CALIFORNIA COASTAL COMMISSION

STAFF REPORT: APPEAL
DE NOVO COASTAL DEVELOPMENT PERMIT

APPEAL NUMBER: A-5-LOB-99-135

PROJECT DESCRIPTION: Construction of a 430-room Marriott Hotel (233 feet high with two restaurants, meeting and banquet rooms, and a health club), and improvement of Victory Park and the Promenade entrance.

EXHIBIT # 3

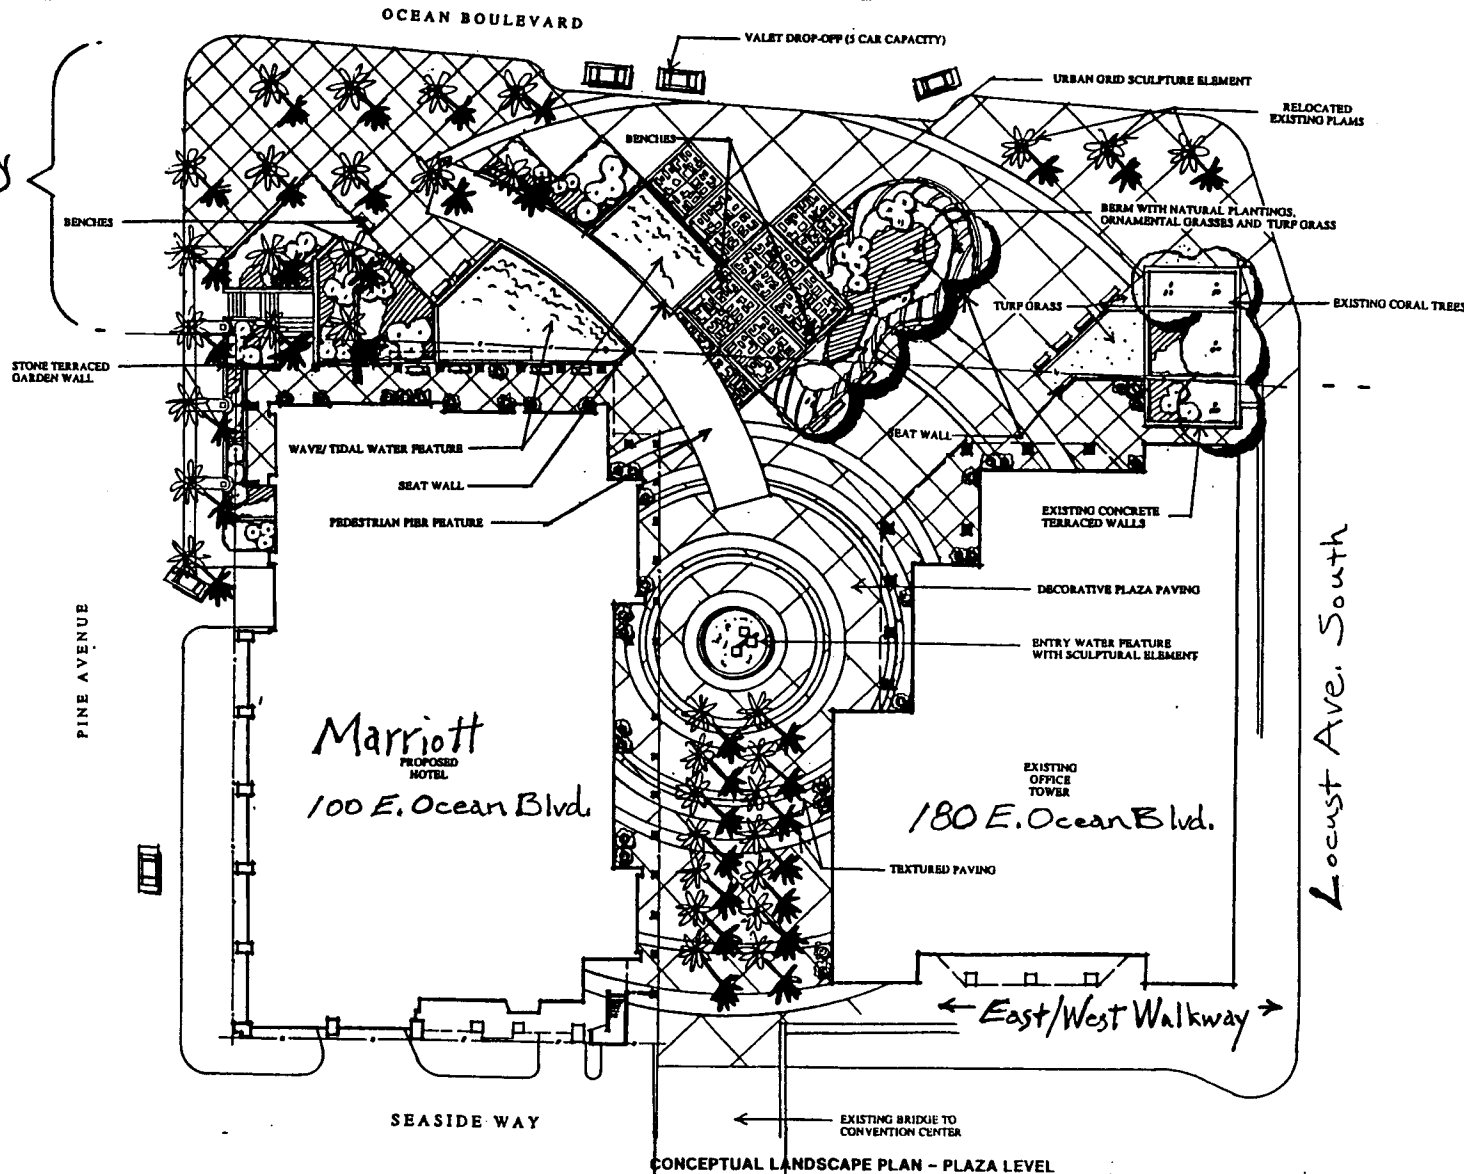
The proposed Victory Park and Promenade entrance design complies with the certified LCP design requirements by using a visually attractive theme that provides physical and visual linkages from Ocean Boulevard to the Promenade South. The proposed park improvement plan includes landscaping, water features, and park benches. Therefore, the proposed project complies with the requirements of the certified Long Beach LCP.

The proposed hotel provides a small corner cut-off to create a cohesive entry feature to the Promenade South from Pine Avenue (Exhibit #3). Therefore, the proposed hotel complies with the certified LCP building site requirements for Subarea 7 of PD-6.

Parking and Traffic Diagram

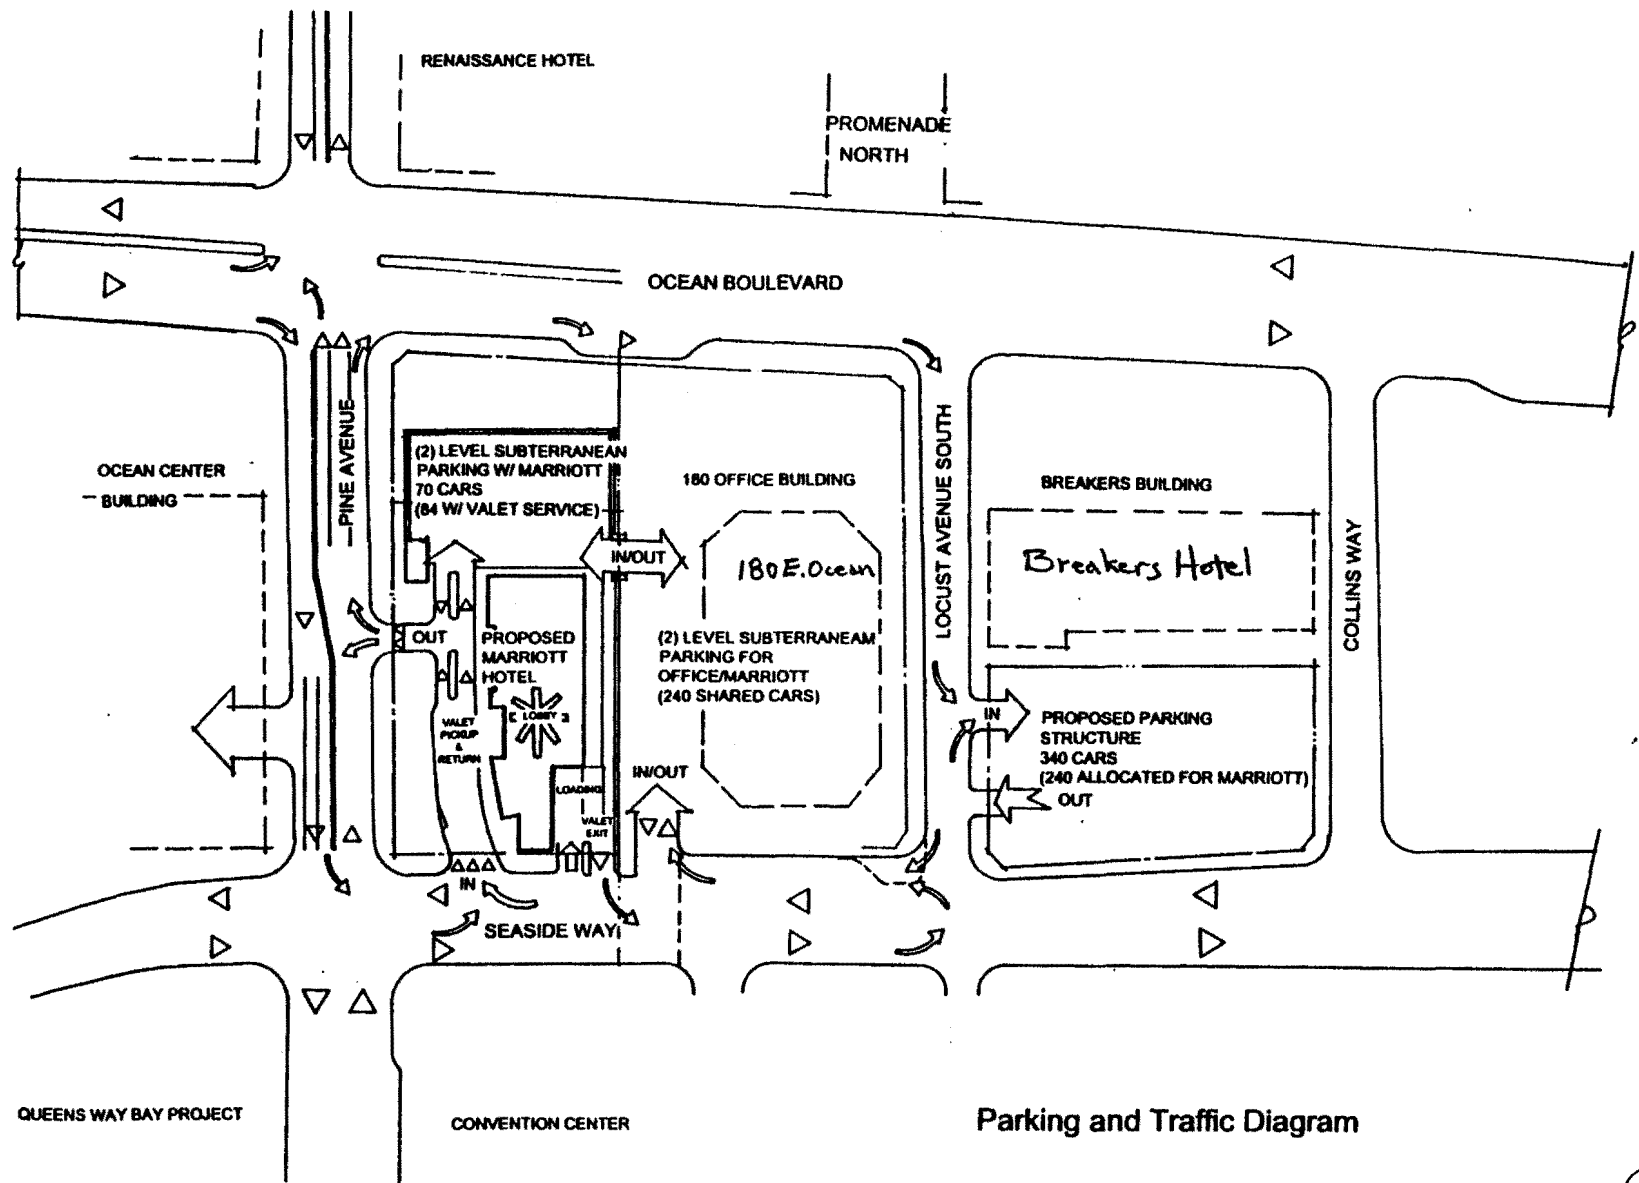
Parking for the proposed hotel is proposed to be provided in three parking garages (Exhibit #4). An on-site two-level subterranean parking garage within the lowest levels of the proposed hotel will provide 70 parking spaces, with space for valets to park 14 additional vehicles. The applicants propose to lease 240 off-site parking spaces in the existing parking garage of the adjacent office building at 180 E. Ocean Boulevard. Another 240 off-site parking spaces are proposed to be provided within a parking structure that would be constructed on a surface parking lot located behind the Breakers Hotel (Exhibit #4). The proposed new off-site parking structure has not been approved or constructed, and is not a part of this coastal development permit action. The City must process a local coastal development permit for the proposed parking structure that would be constructed on a surface parking lot located behind the Breakers Hotel.

The proposed parking plan complies with the above-stated LCP requirements for off-site hotel parking. All proposed parking supplies are located within six hundred feet of the proposed hotel. A special condition of approval requires that, prior to issuance of the coastal development permit, the applicants obtain the necessary approvals, including a local coastal development permit, to construct and use the proposed off-site parking consistent with the above-stated LCP requirements. The local coastal development permit for the construction of the proposed off-site parking garage on the surface parking lot behind the Breakers Hotel must ensure that the existing parking spaces on the site are replaced. In addition, the proposed off-site parking garage must be constructed prior to, or concurrent with the proposed hotel, and must be dedicated and available for use prior to the hotel opening for business. Only as conditioned does the proposed development conform to the requirements of the certified Long Beach LCP.

EXHIBIT # 5
PAGE 1 OF 1

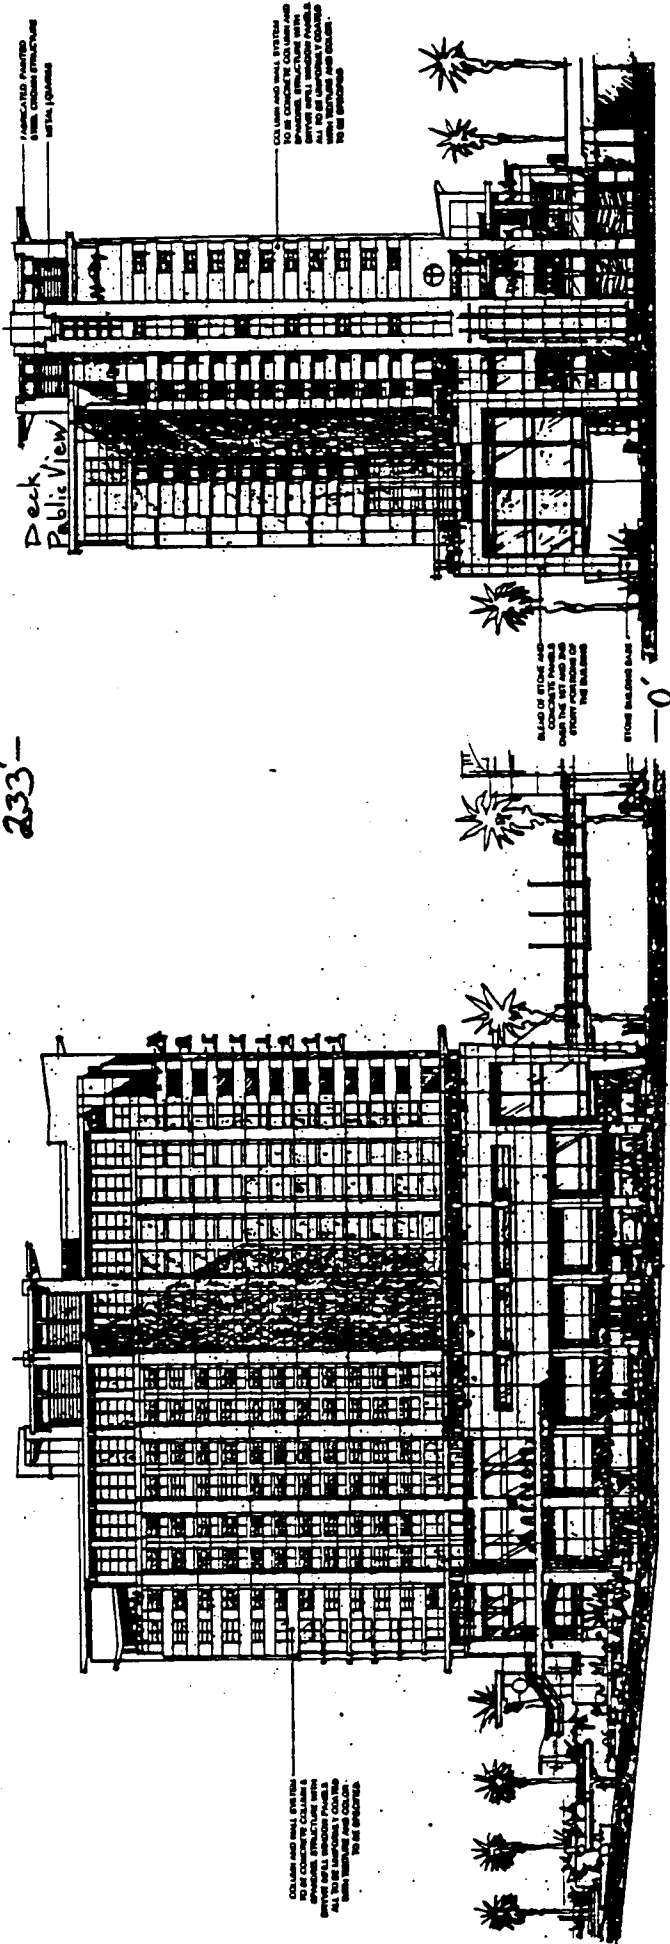
The proposed hotel is 233 feet high measured from Seaside Way (Exhibit #5). Therefore, the proposed hotel complies with the 250-foot height limit for Subarea 7 of PD-6.
